PROJECT # 9918

City of Coos Bay Plan Review APPROVED As submitted Per correction letter 12-17-99

5113 PORTLAND ROAD N.E. Salem, Oregon 97303 (800) 745-3406	
Customer:		FAMILIAN NORTHWEST	
End User:		FAMILIAN NORTHWEST	
Location:		COOS BAY, OR	
Det. By	Chk By	Date	Scale
TIS		10-19-1999	N.T.S.
Building ID	Job Number	Sheet Number	Issue
A	0801-183342	F1 of 2	0

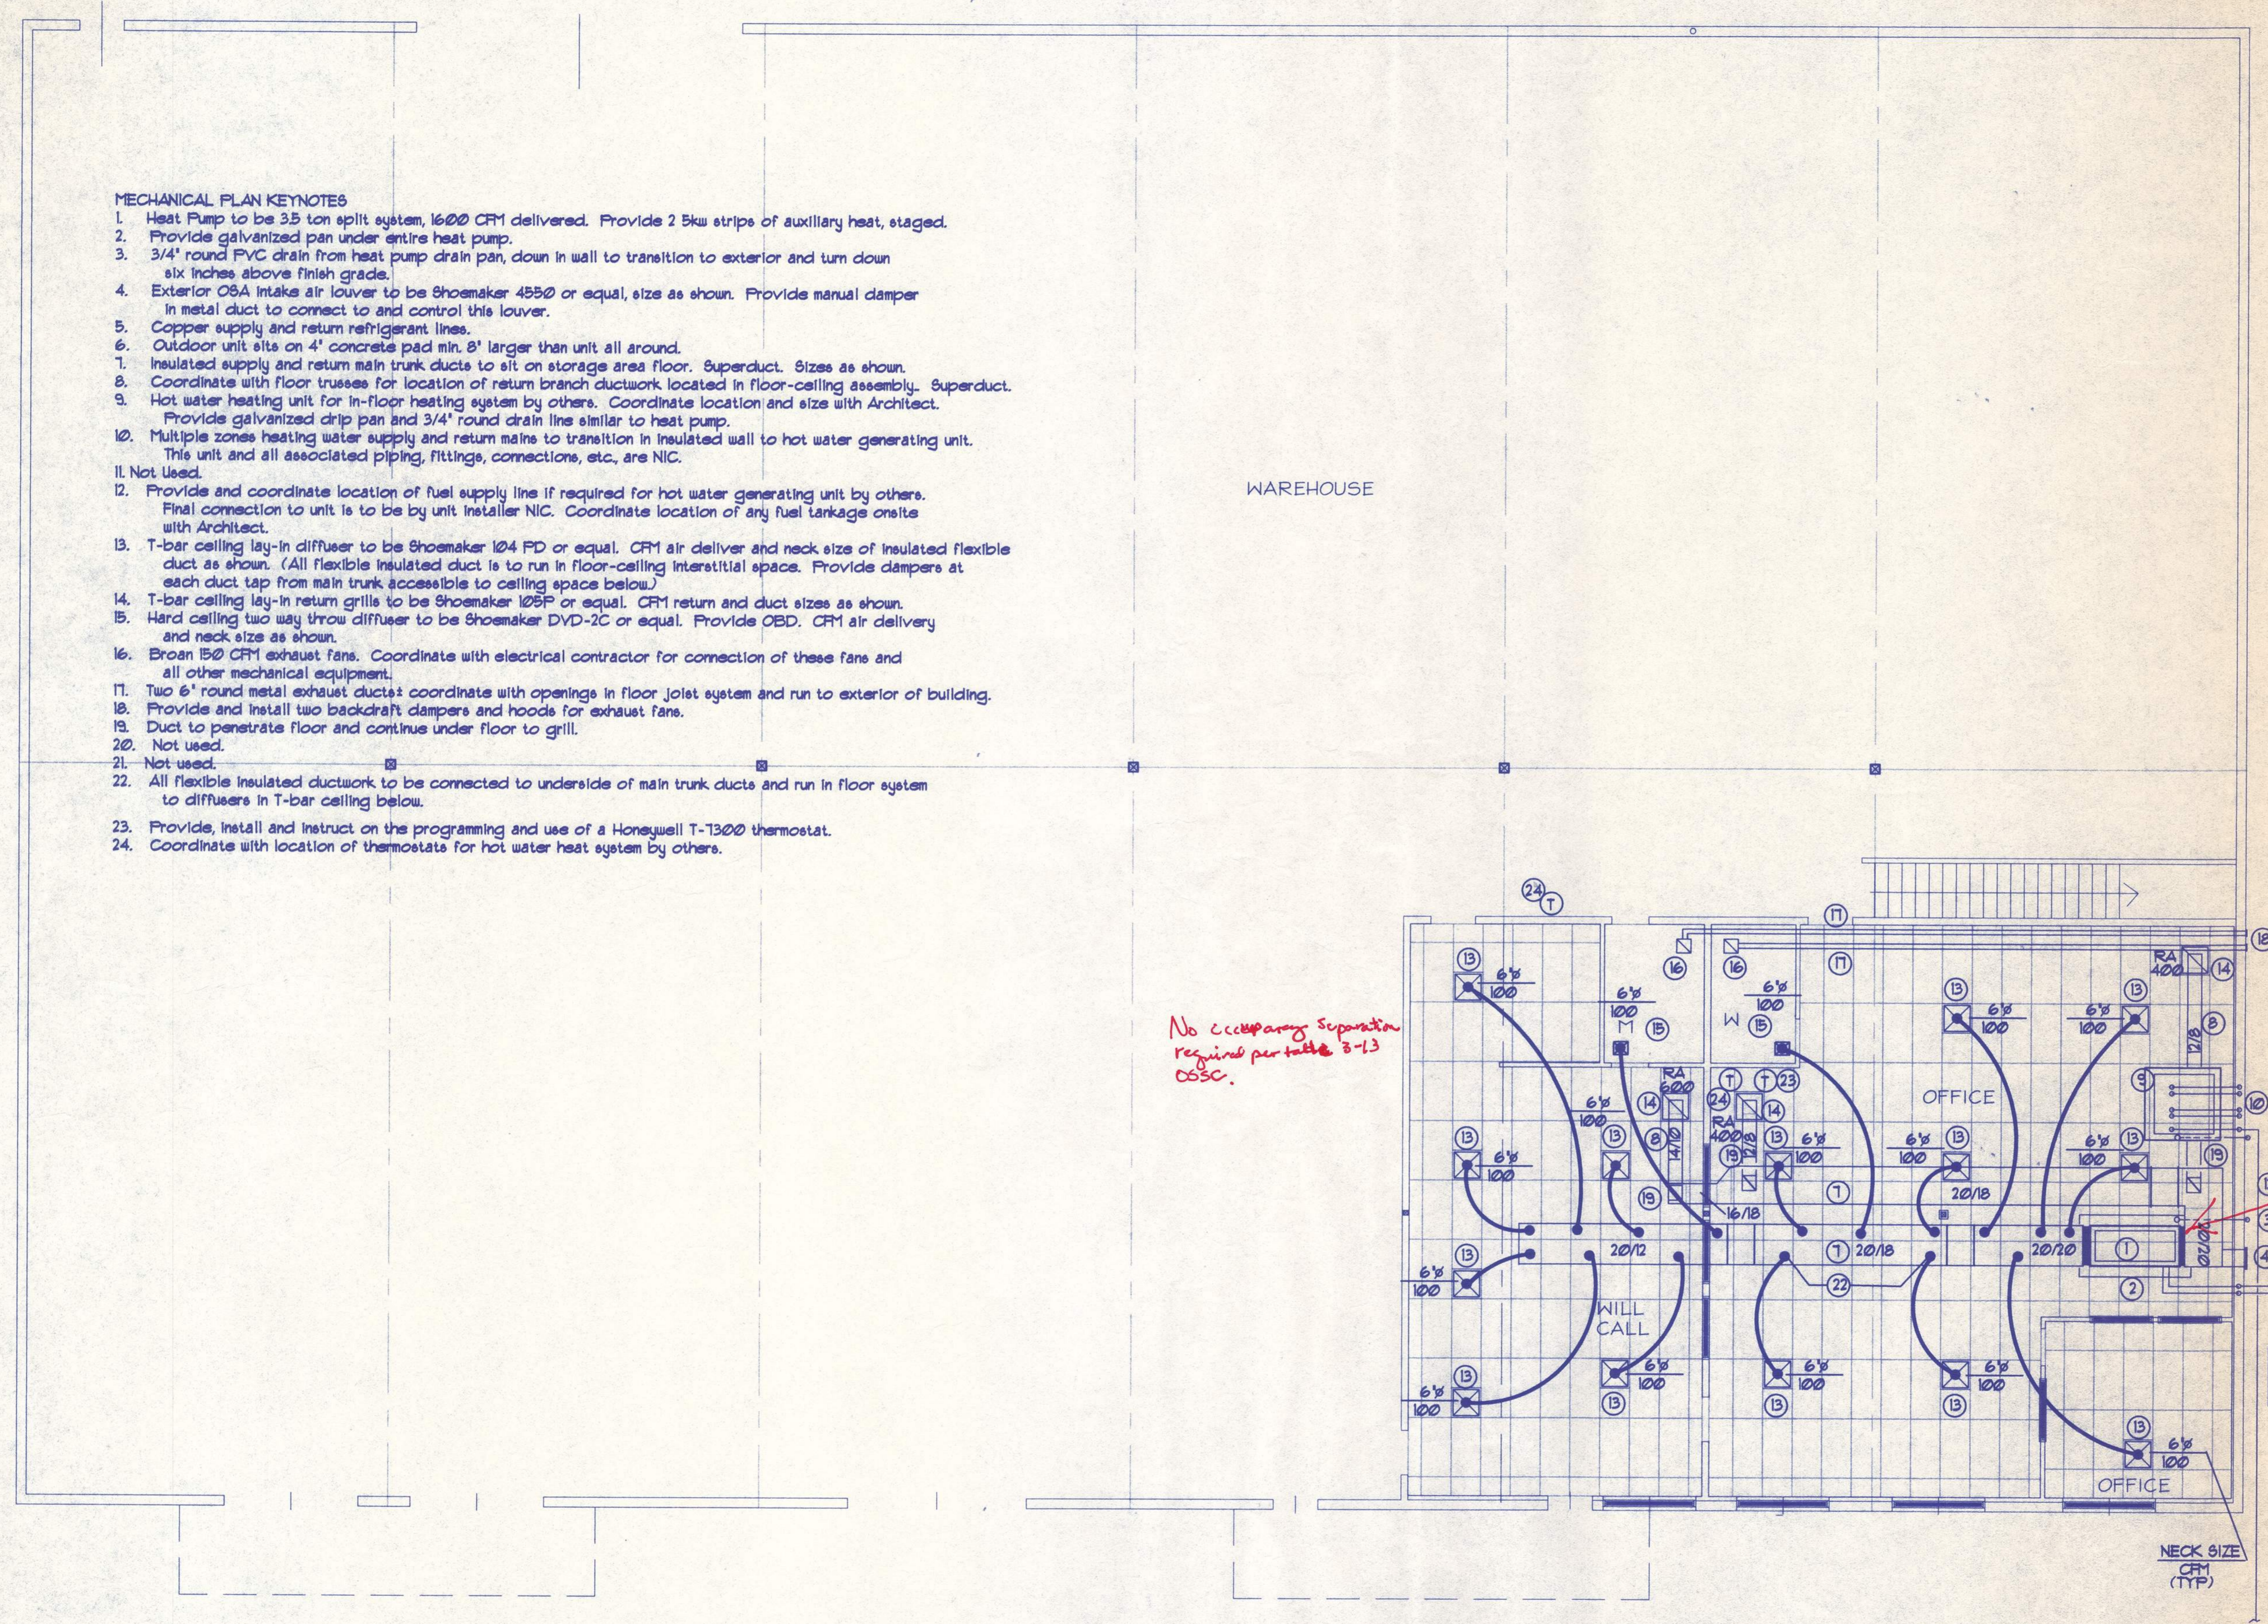
No ceiling separation required per table 3-1.3 OSSC.

Provide access and service space per section 306 of the Oregon Mechanical Specialty Code
